ADDENDUM NO. 1

Job No. F70C616E
SAND ISLAND STATE RECREATION AREA
SEWER SYSTEM IMPROVEMENTS
PHASE 2: PUMP STATION 3 RELOCATION & FM 3 REPLACEMENT
Honolulu, Oahu, Hawaii

02/22/21

| APPROVED: | | DRAWING NO. | C005A | |

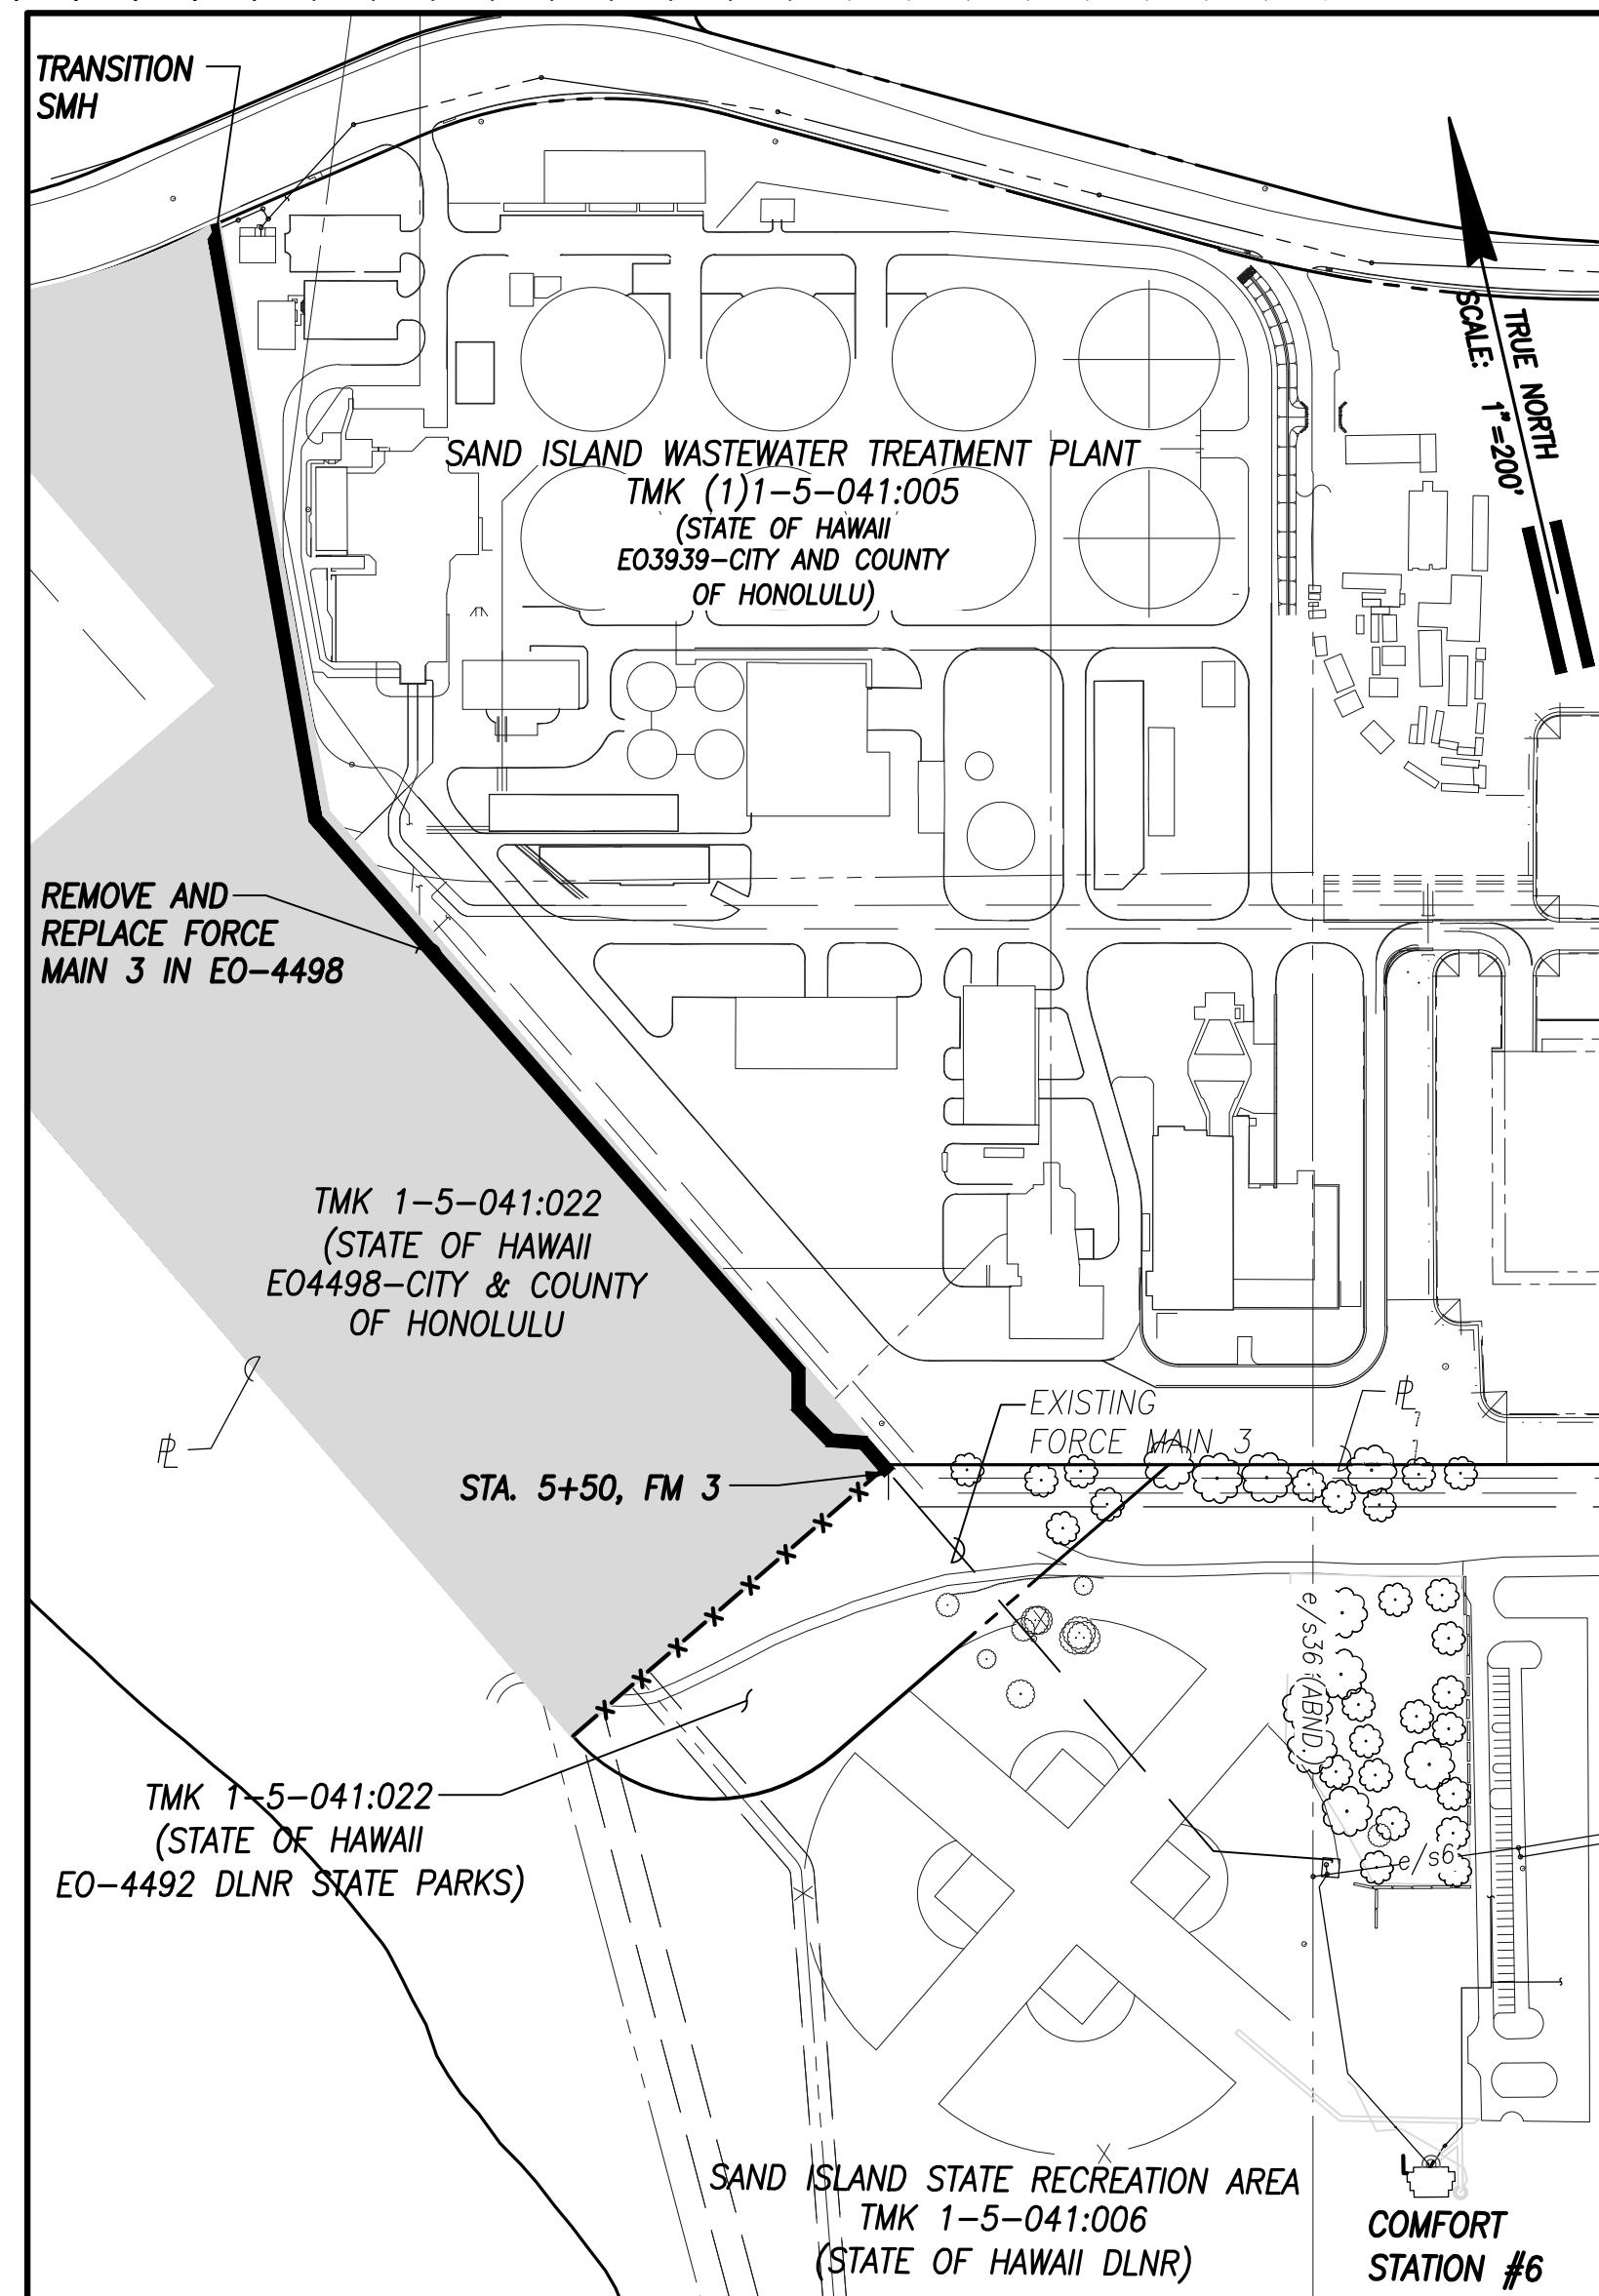
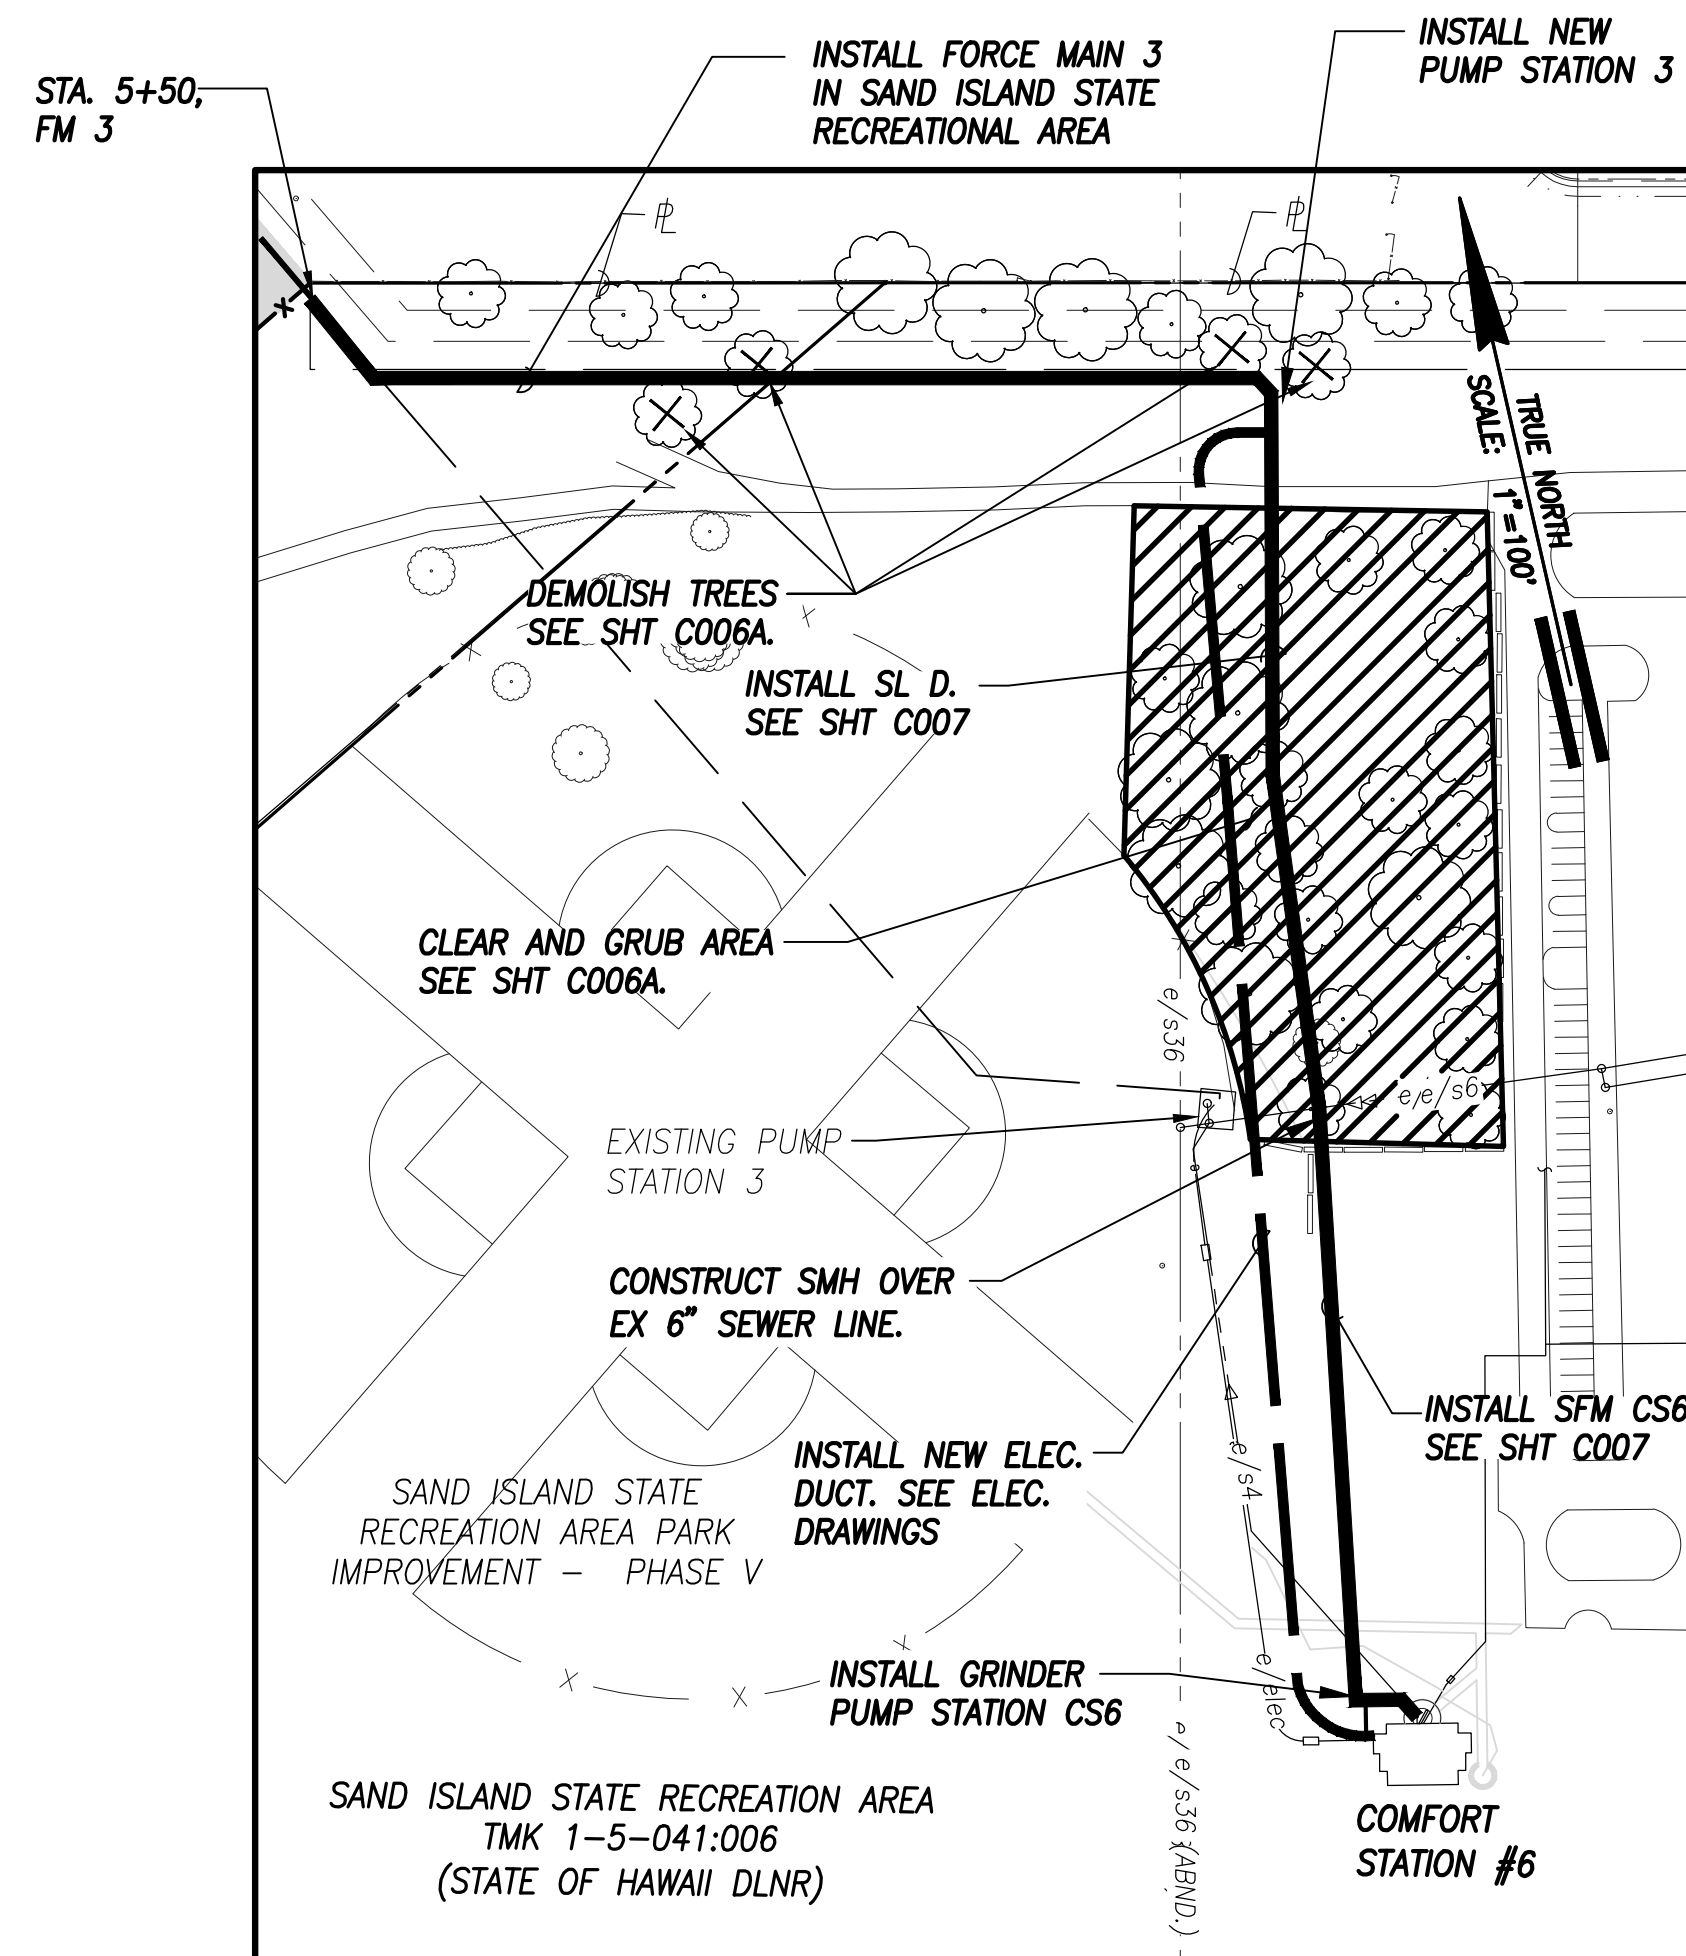
- 1. Sheet C005A, “Phasing Plan.”
- 2. Sheet C006A, “Demolition Plans – 1”
- 3. Sheet C006B, “Demolition Plans – 2”
- 4. Sheet C020A, “Chain Link Fence Details”

46. Sheet C005, note 1 state “Contractor must complete installation and testing of Phase 1 work and be cleared out of the EO-4498 area by June 7th, 2021. No Exceptions.” However, page P-11 of the proposal states that completion of Phase 1 of the contract shall be by June 25, 2021. Please clarify when phase 1 is to be complete.

Answer: See revised proposal in this addendum. Phase 1 to be completed by June 7, 2021. Also, the completion date for Phase 1 in the last paragraph of Section Q in the Information to Bidders Section of the Specifications shall be changed to June 7, 2021.
